SAVAGE SUBDIVISION – PRELIMINARY PLAT

900 W 85 SOUTH

CITY COUNCIL MEETING

FEBRUARY 2, 2023

C702

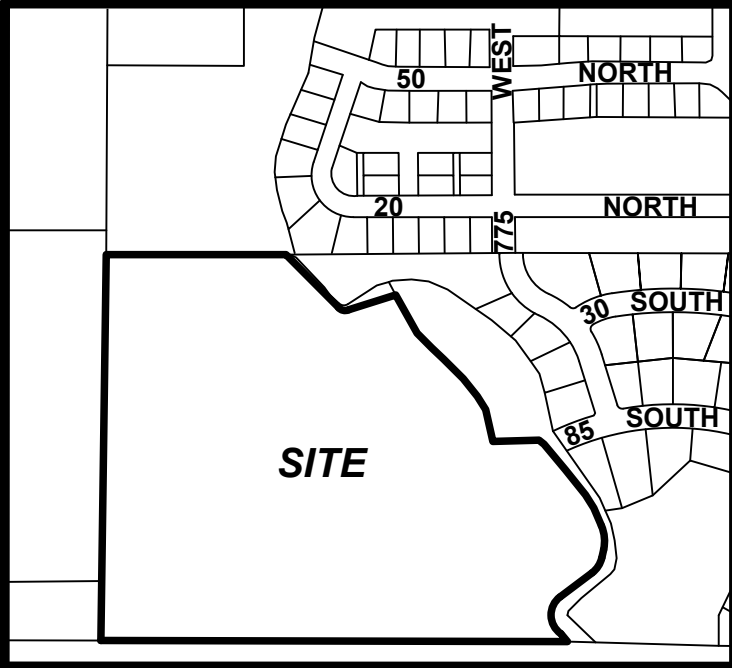
WILL A 12' DRIVE BE WIDE ENOUGH? THIS IS NOT ENOUGH FOR A TRUCK WITH TRAILER TO NAVIGATE WELL, OR INCOMING AND OUT GOING CARS TO NEGOTIATE THIS WELL.

PLAT SHEET 1

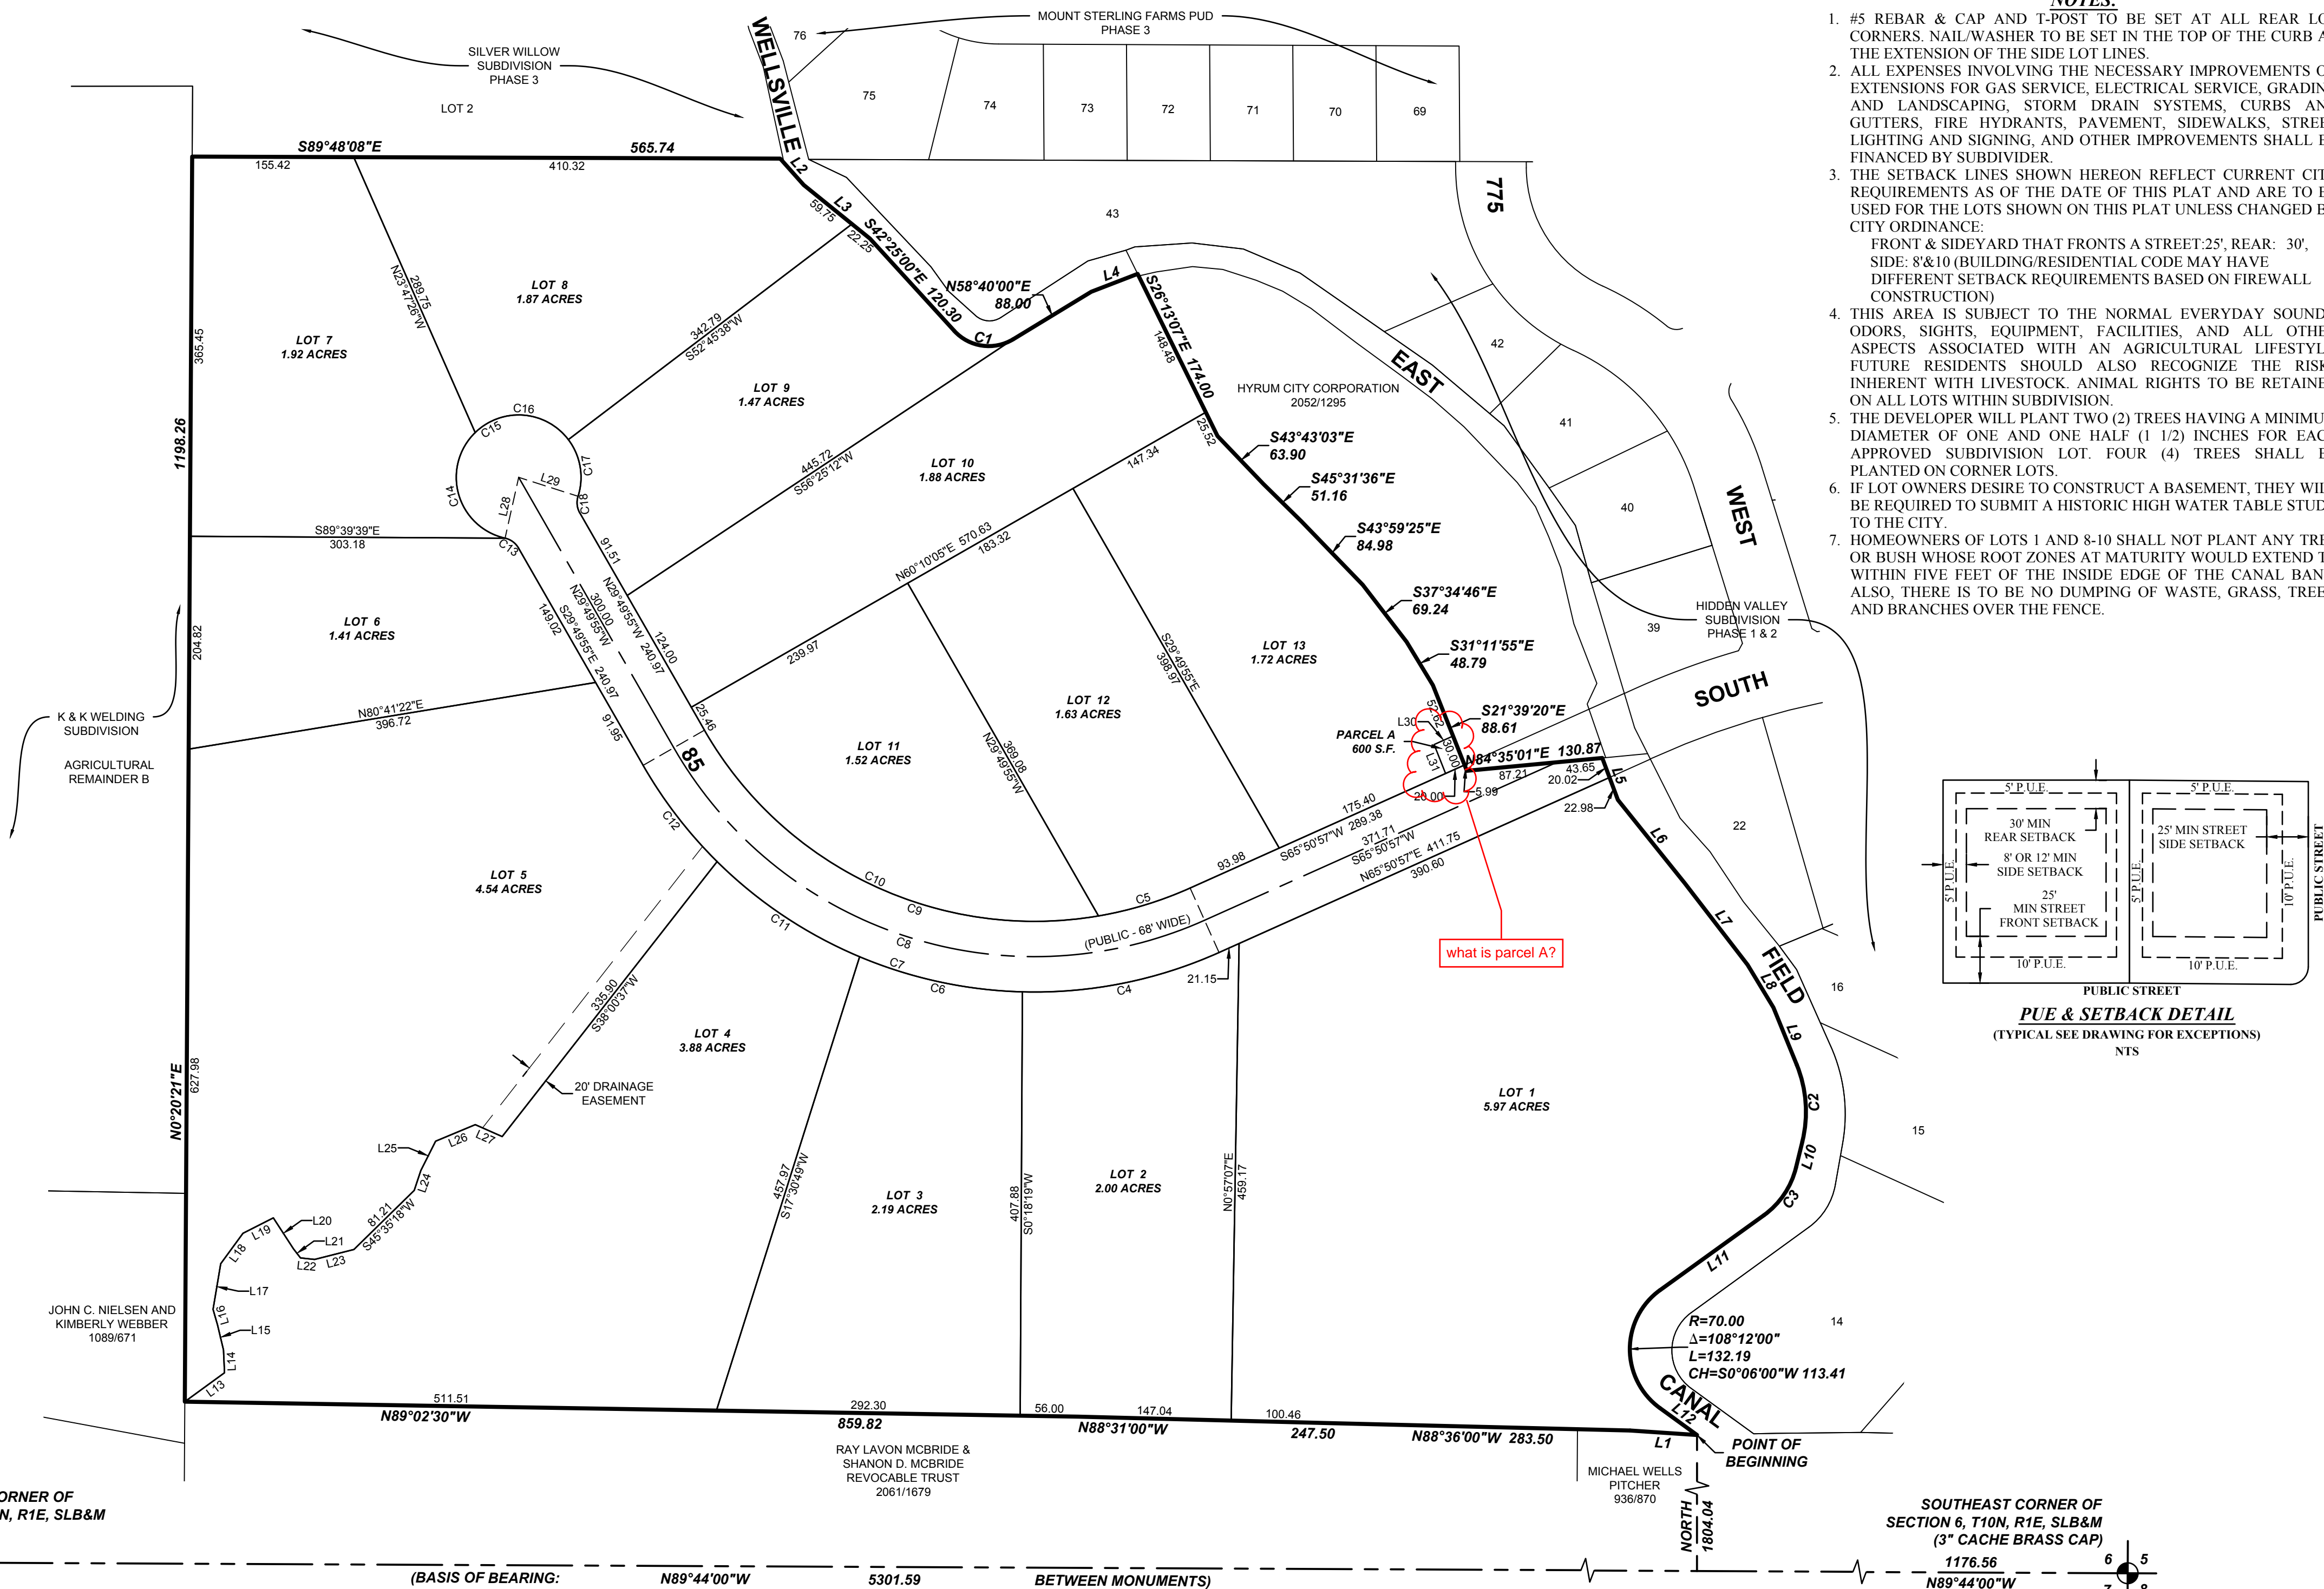
SHOW MONUMENTS AT KEY POINTS IN ALIGNMENT

SHOW EASEMENT FOR EXISTING DRAIN PIPE FROM BASIN TO RIVER

WHAT IS GOING TO HAPPEN WITH PARCEL A? IS THIS A PRIVATE PARK? HOA/MAINTENANCE.

FENCE ALONG CANAL OR PIPE CANAL IS NEEDED PER CITY CODE.

DETAIL SHOWS 12 FOOT SETBACK, CHANGE TO 10 FOOT

NEED WATER AND SEWER AUTHORITY BLOCK, REPLACE REDUNDANT ATTORNEY BLOCK.

NOTE ON TREES NEAR CANAL, CHANGE INSIDE EDGE TO TOE OF SLOPE

C201

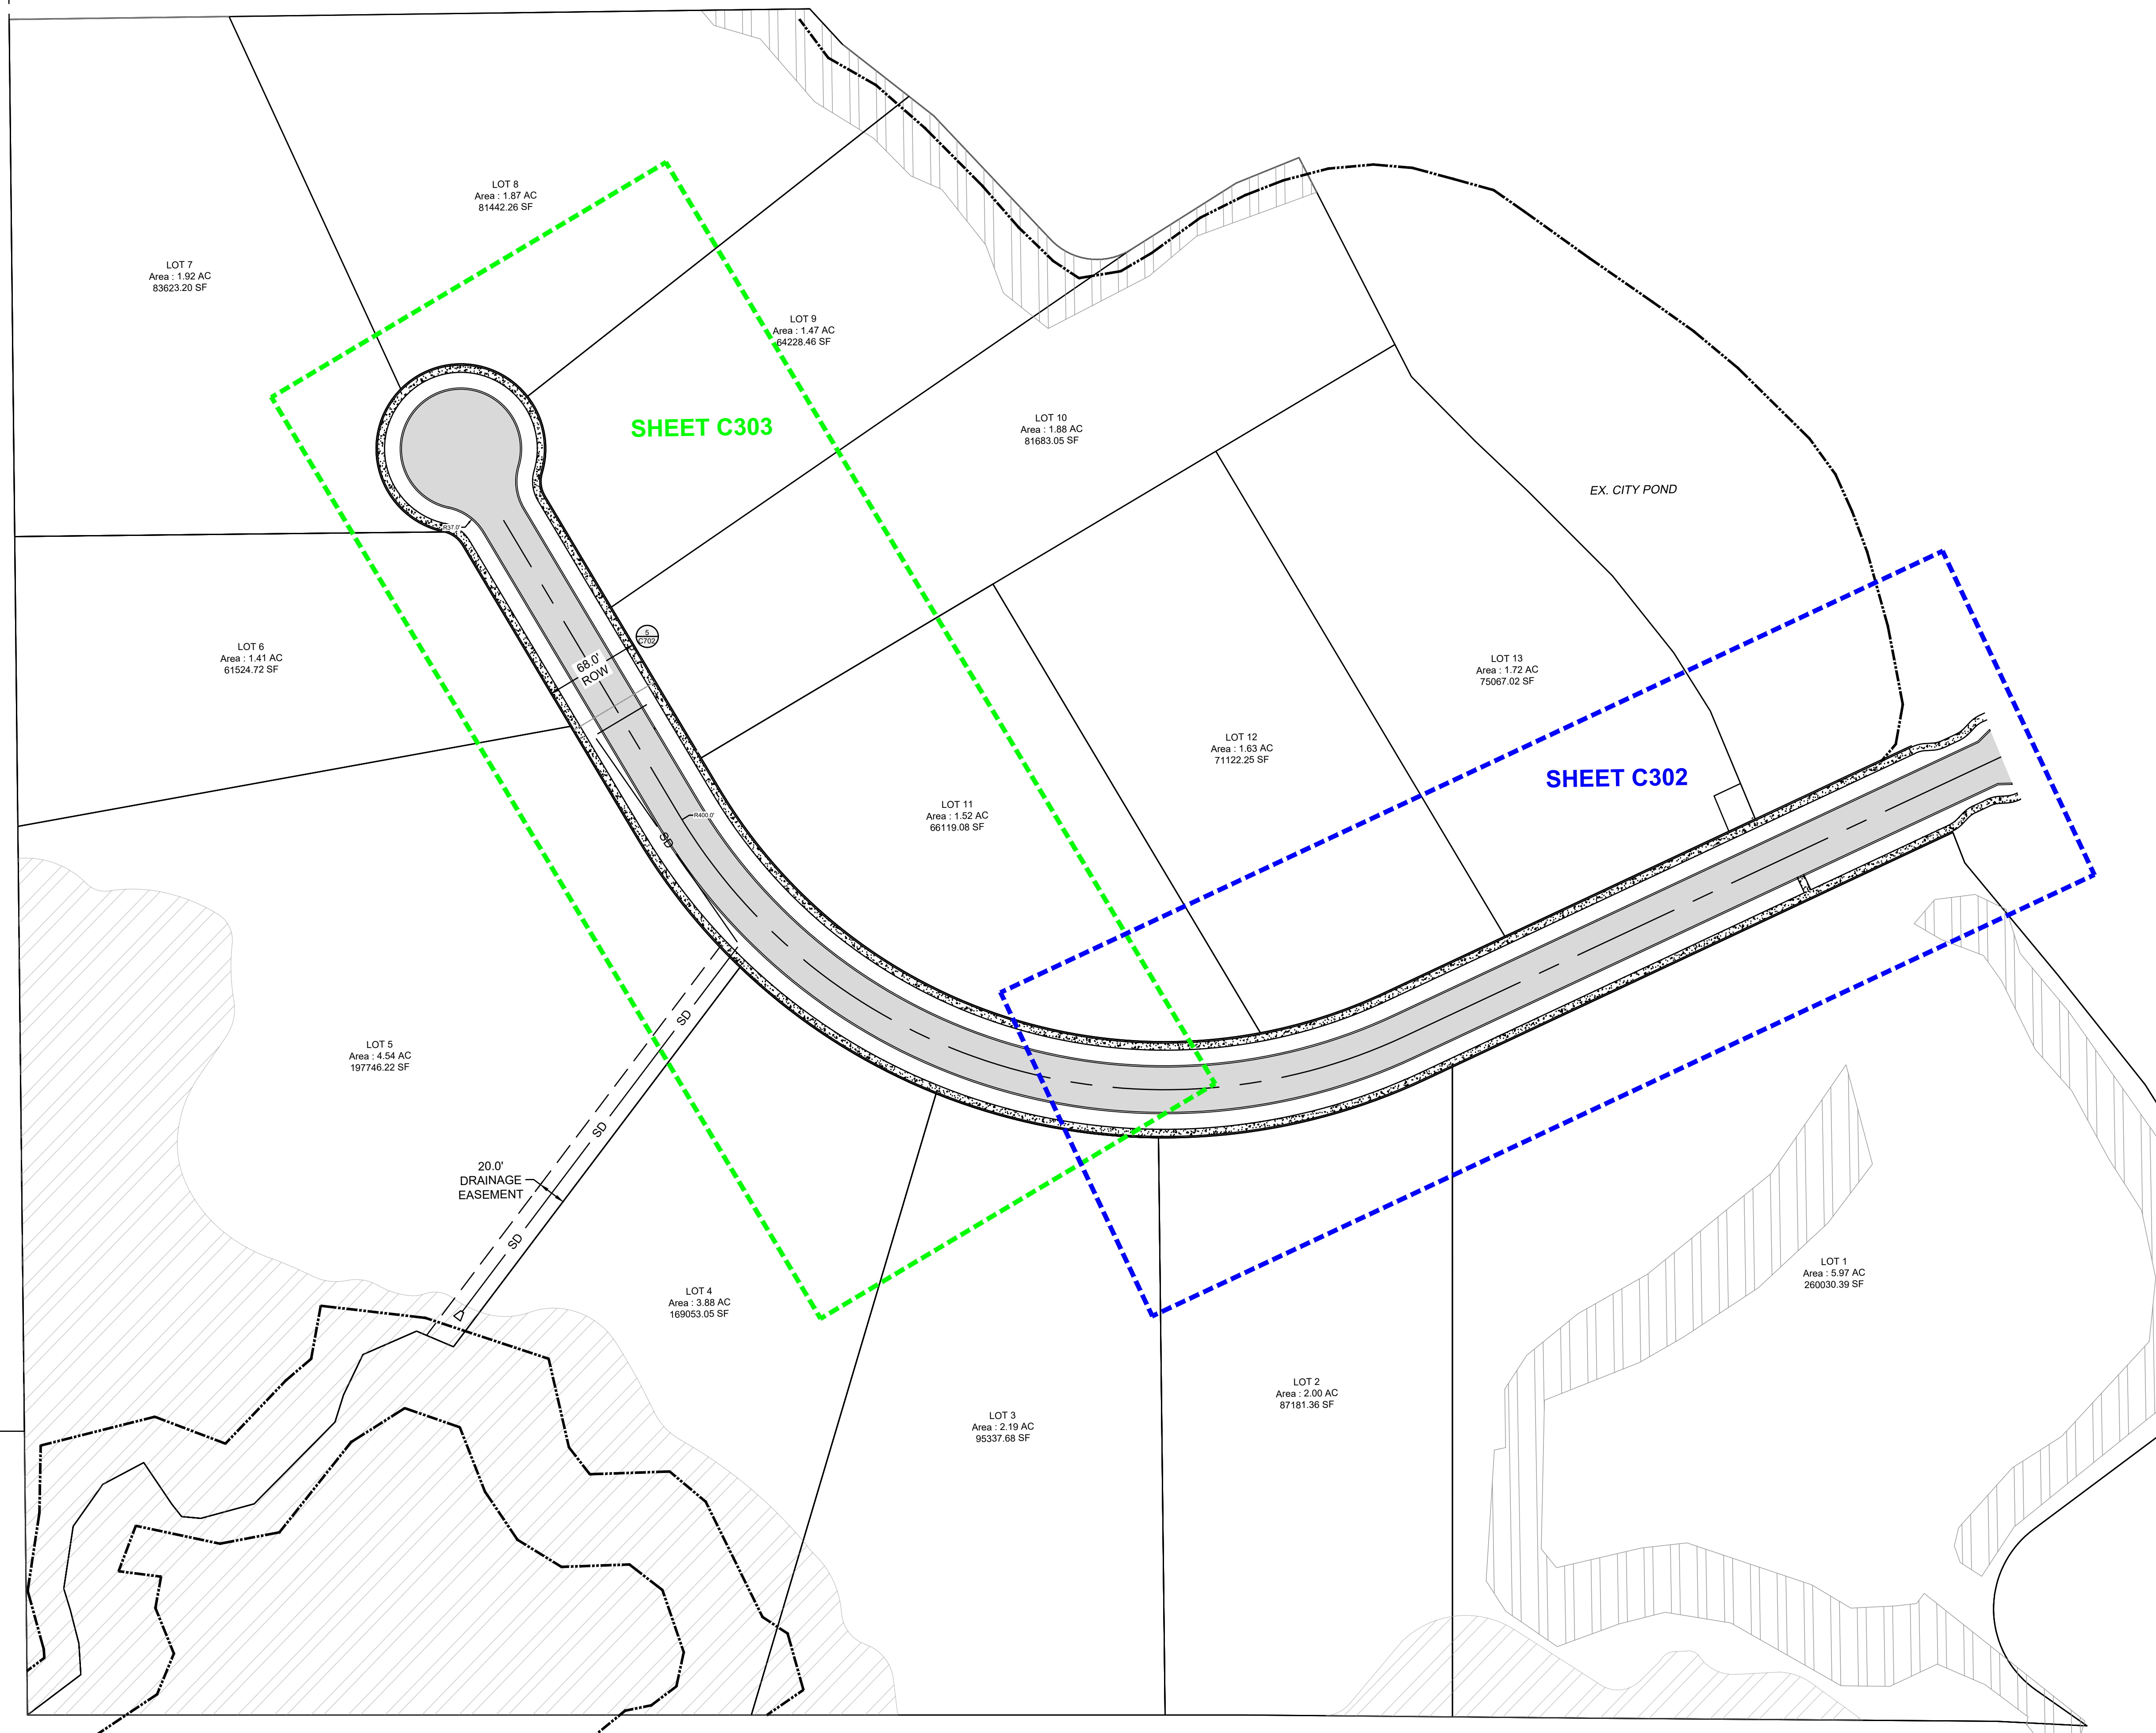
NOTE 7 CHANGE K TYPE COPPER OR APPROVED EQUAL (POLY)
